Land East of Newgate Lane East, Fareham

Transport Assessment Addendum

Client: Miller Homes & Bargate Homes

i-Transport Ref: TW/ITB10353-024a

Image 2.1 – Extract of Access Point

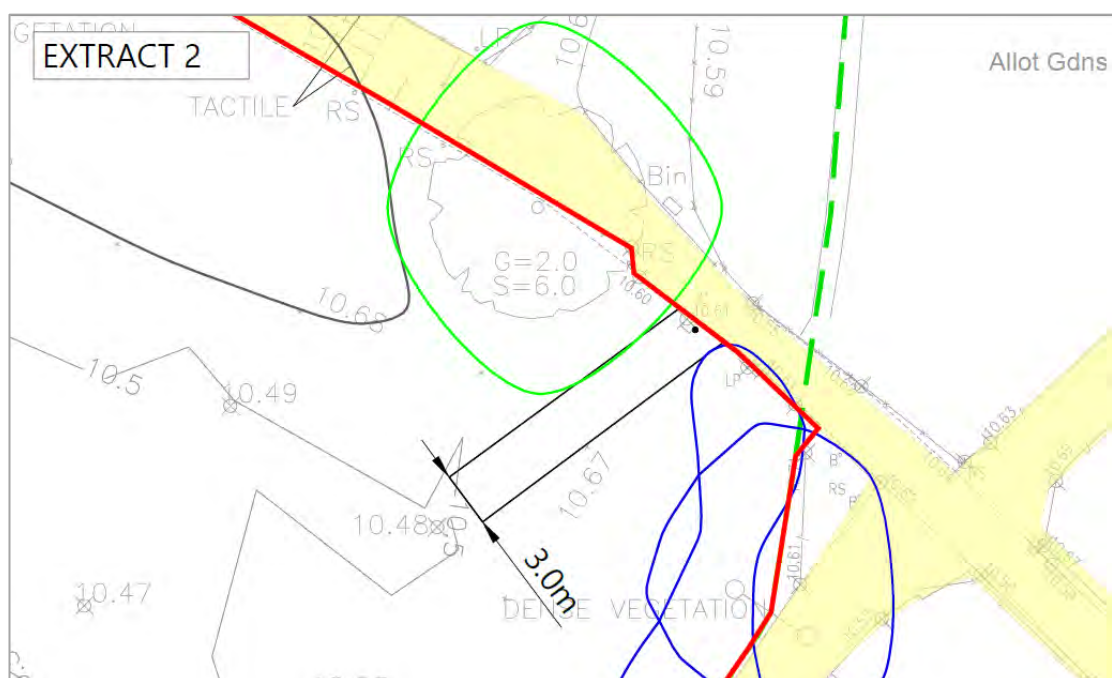
2.4.3 HCC requested further design detail for Access Point 2, and confirmation that the connections can be achieved, as well as identifying that the arboriculture / ecological impacts will need to be considered (noting these concerns are surmountable).

2.4.4 **Drawing ITB10353-GA-031A**, provided in the TA (extract at **Image 2.1**), identifies sufficient detail to consider the delivery of the access connection, demonstrating a 3m shared footway / cycleway linkage to the PROW.

2.4.5 This includes consideration of impacts on adjacent trees and vegetation with the tree survey included in the drawing. The proposed connection is shown to be provided outside of the Root Protection Areas of Tree T29 (A-Category Tree) and Group G21 (group of B-Category Trees). The Arboricultural and Ecological assessments supporting the application consider the proposed connections and raise no concerns, in particular that no significant tree loss is required.

Image 2.2 – Northern PROW Connections (Access Points 1 and 2)

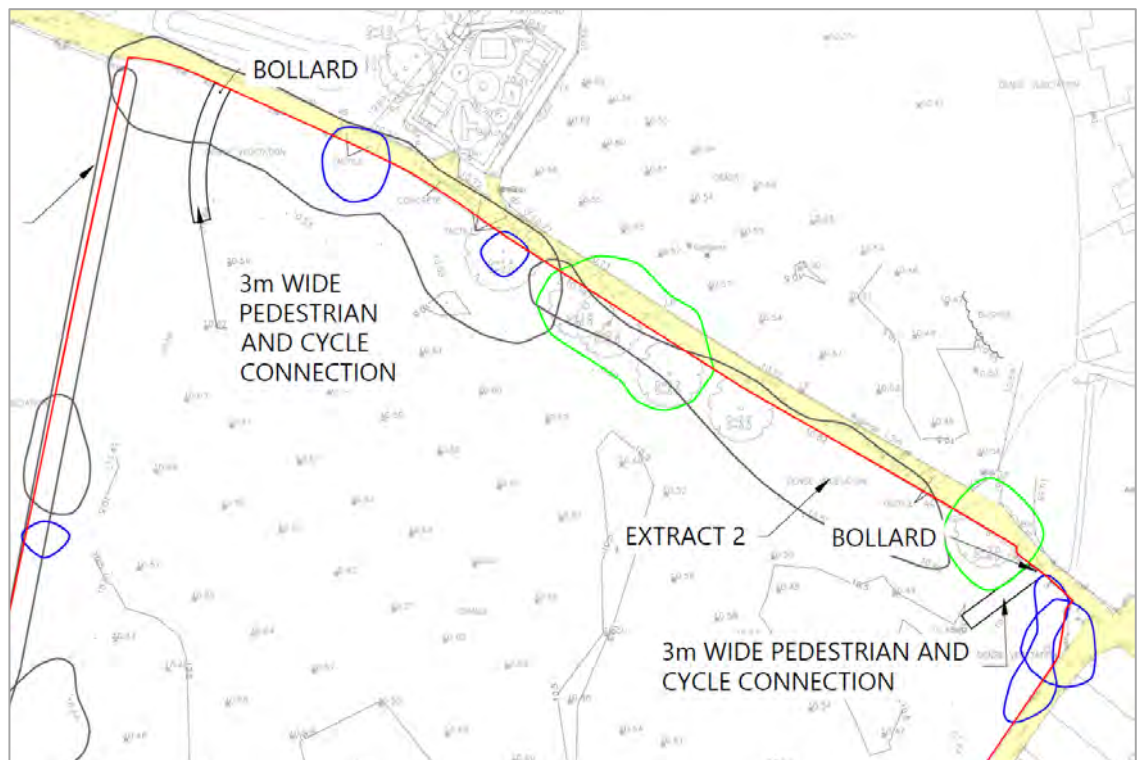
Deliverability of Access Points 1 and 2

2.4.6 On **Drawing ITB10353-GA-031A** the public highway boundary is depicted in a yellow shade, obtained from HCC records, shown against the planning application boundary, depicted in a red edged line. This demonstrates how the access connection is formed between the application site and the public highway, as extracted at **Image 2.2**.

Image 2.3 – Public Highway at Access Point 3

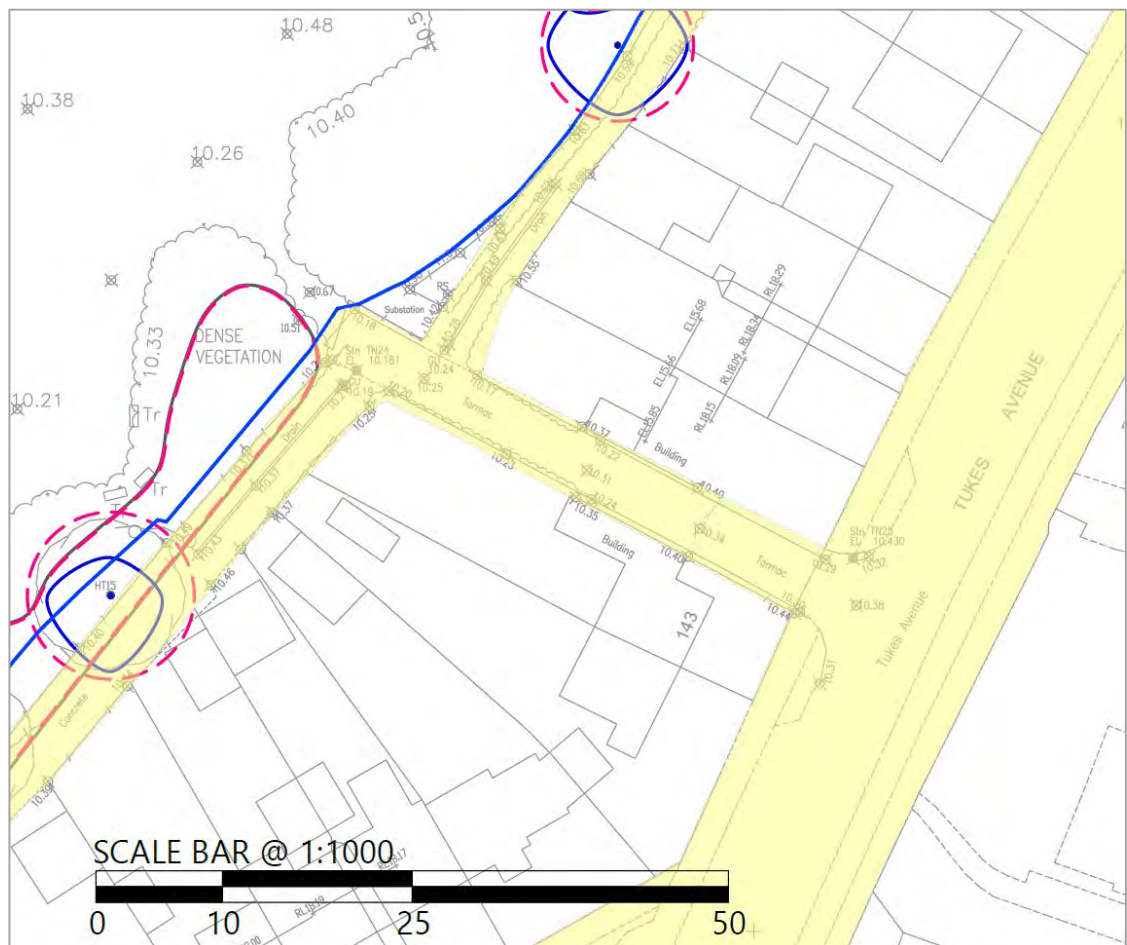
Amend the existing bellmouth to Tukes Avenue to a cross-over junction	The bellmouth is amended to a cross-over, shown on Drawing ITB10353-GA-032B .
Provide crossing points at Tukes Avenue to address the new desire lines	A new crossing point is proposed at Tukes Avenue directly south of the service road connection, on the desire line between the Appeal Site and School. This is formed by build outs to improve pedestrian visibility.
Progress a Traffic Regulation Order to prevent parking on the service road	The design of the connection will dissuade parking from occurring. In the event that a Traffic Regulation Order is required to enforce this, it will be progressed.
Provide wayfinding signage to the BRT	Wayfinding signage has been added.

2.4.13 **Drawing ITB10353-GA-032B** demonstrates the public highway boundary (shaded yellow), obtained from HCC records, against the planning application boundary, depicted in a blue edged line. This demonstrates how the access connection is formed between the Appeal Site and the public highway and that the application boundary and public highway are contiguous.

2.4.14 The scheme is within the control of the Appellants to deliver, subject to completing works on the public highway, to be achieved through a Section 278 Agreement with HCC.

Image 3.1 - Scope of WCHAR Extension

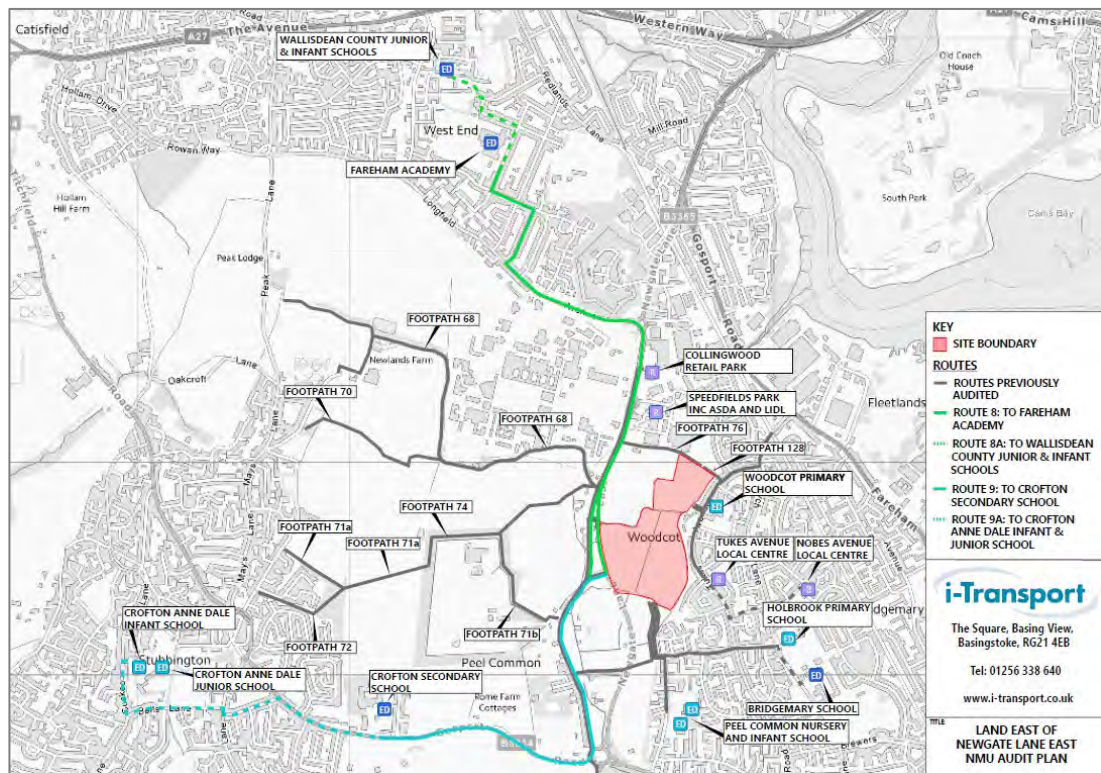
- 3.3.5 It is however acknowledged that some pupils may still choose to attend the Catchment Schools and that HCC has no current plans to revise school catchments; therefore, the WCHAR has been extended to consider these routes and identify any improvements needed to ensure safe access to education is available to residents of the Appeal Site.

- 3.3.7 **Appendix K** presents the extended WCHAR with the scope presented at **Image 3.1**, as well as identifying the other educational establishments for context.

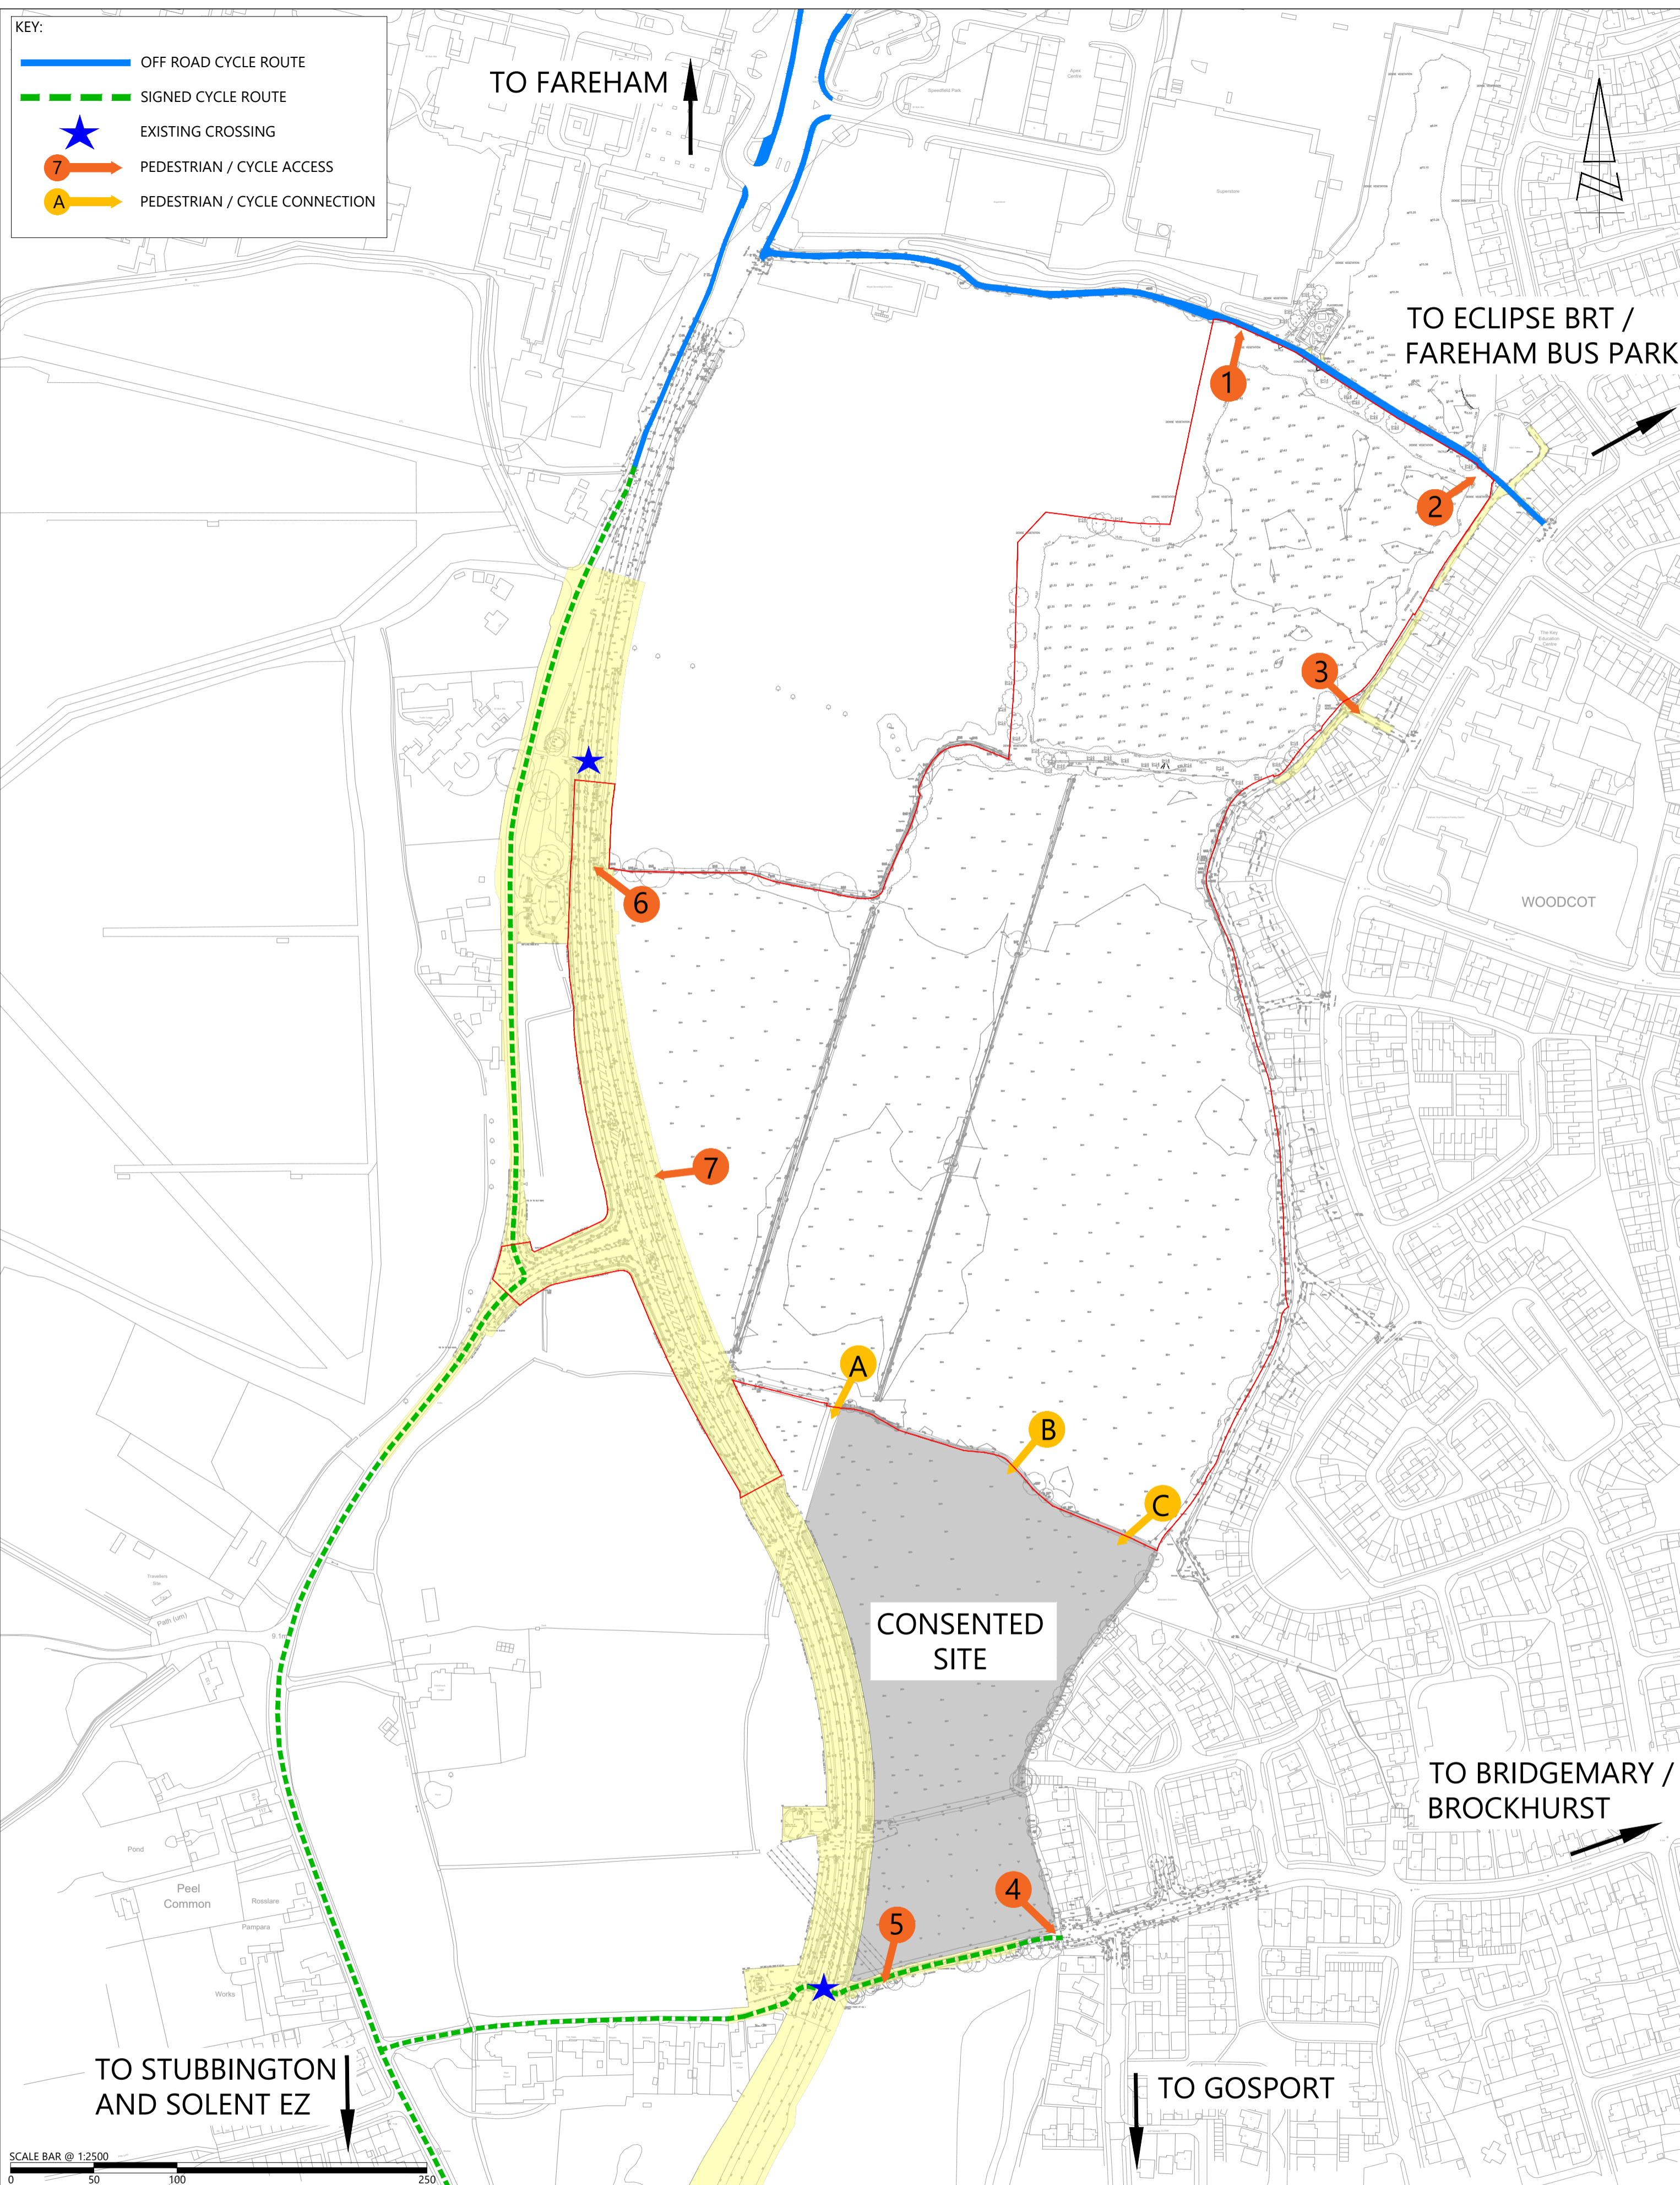
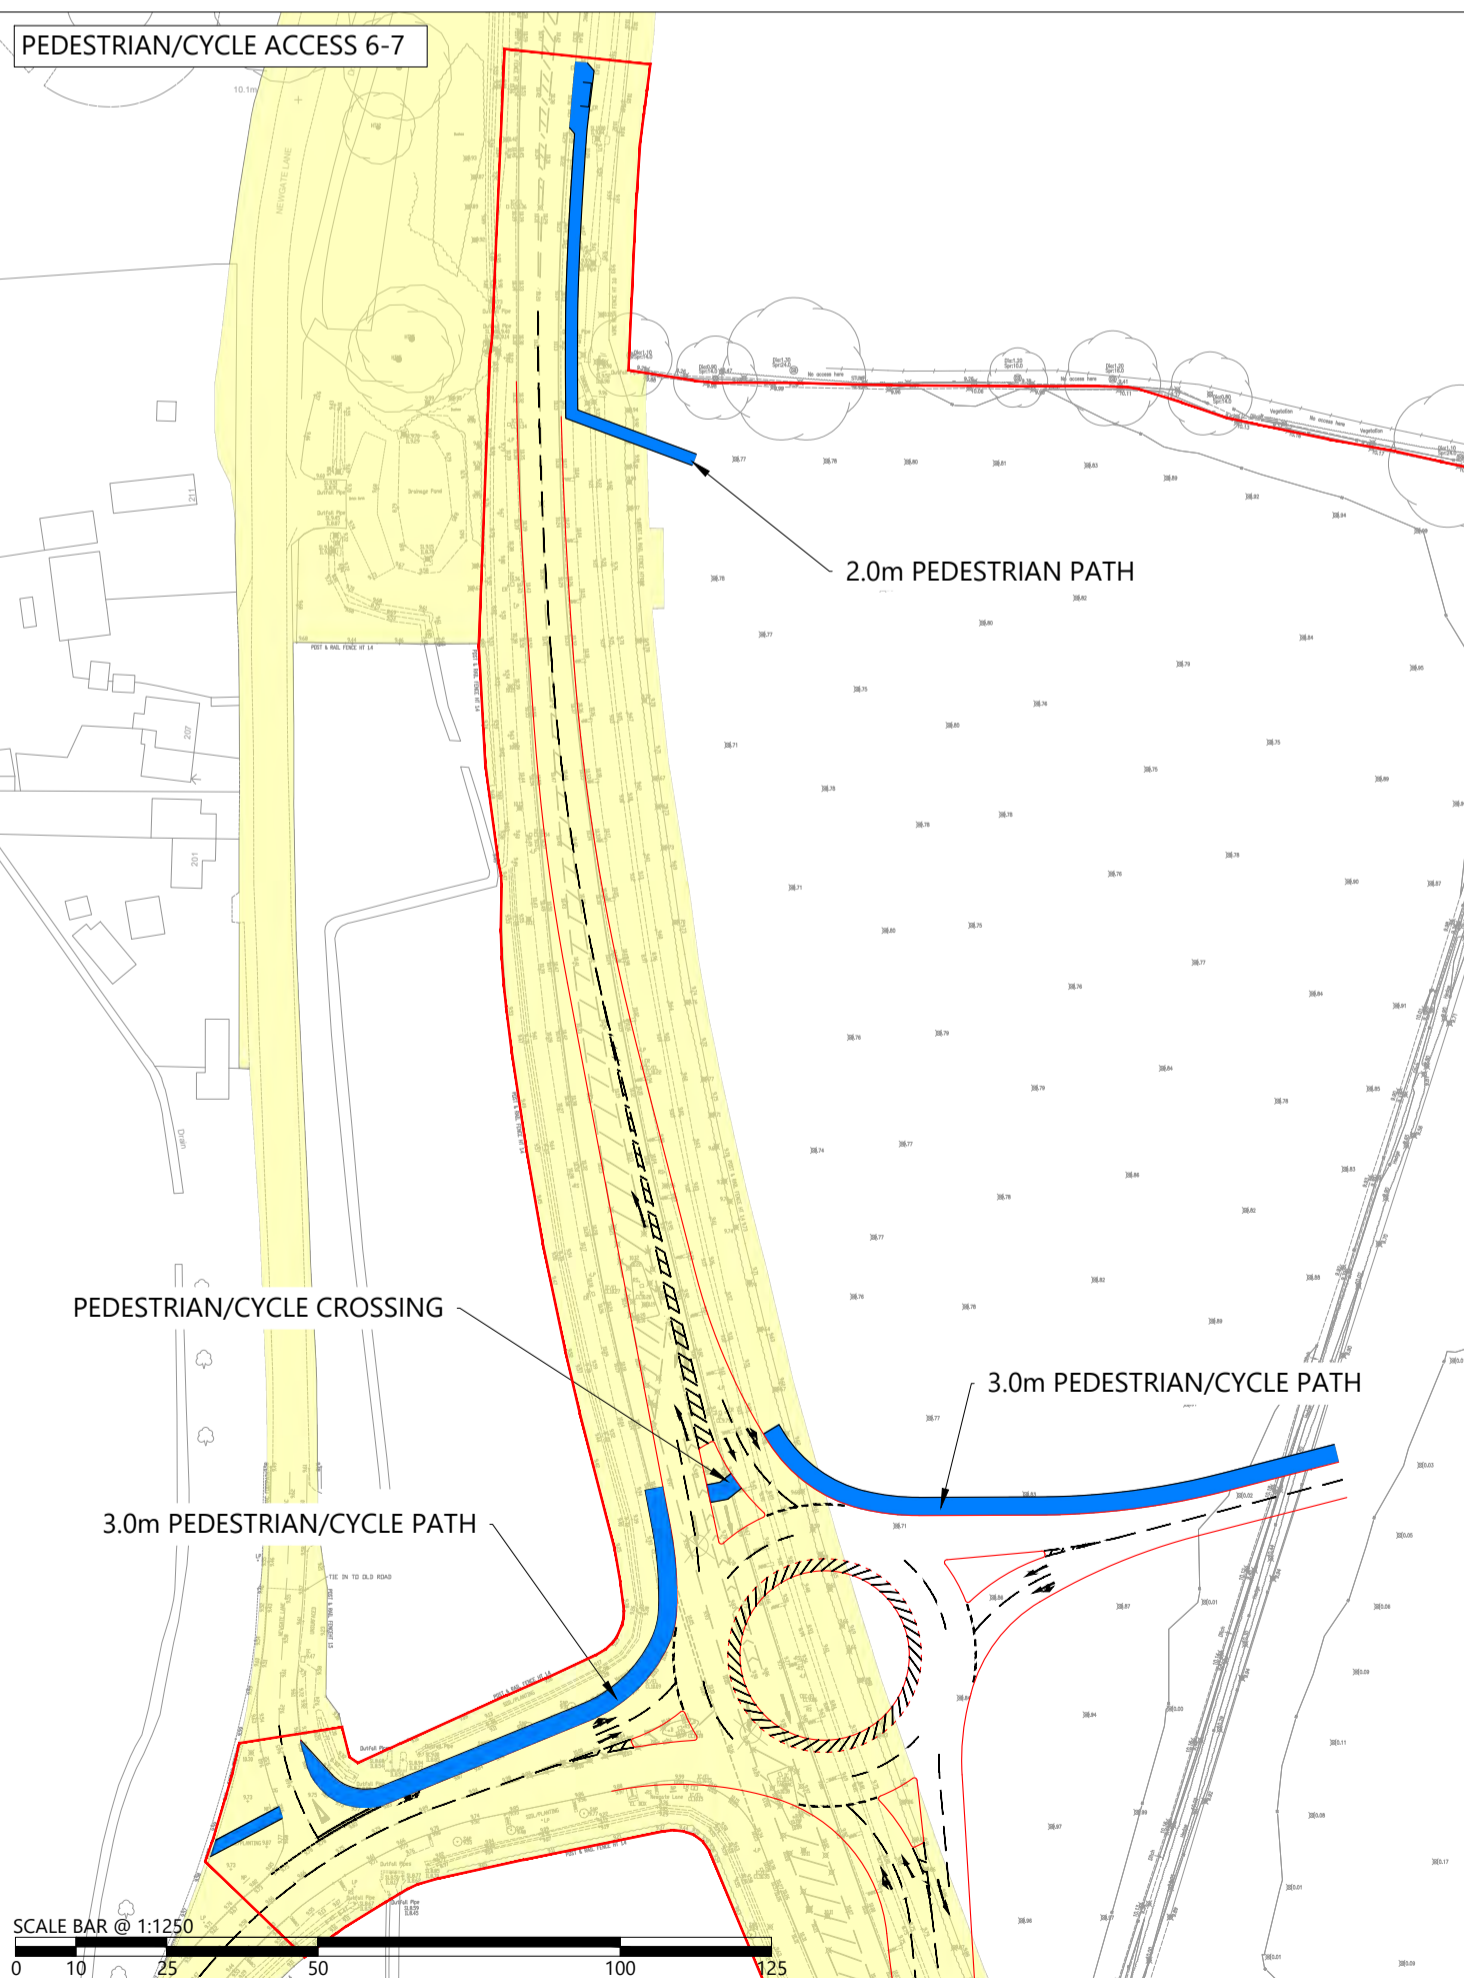
2.4.1 HCC raise various comments in relation to each of the proposed arrangements for pedestrian and cycle access (as depicted on TA **Drawing ITB1053-GA-031A**). These are addressed in turn.

2.4.27 Taking the active travel access strategy comprehensively (**Drawing ITB10353-GA-031 A**), there is little justification to upgrade Access Point 6 for cycle usage, which would require upgrading of the associated crossing of Newgate Lane East. There are six proposed cycle connections serving the site, provided in all directions, with two to the south at the eastern and western corners of the site, two to the north, again at the eastern and western boundaries, to the east (to Tukes Avenue) and to the west at the proposed access roundabout. This ensures high-levels of permeability specifically to prioritise pedestrians and cyclists.
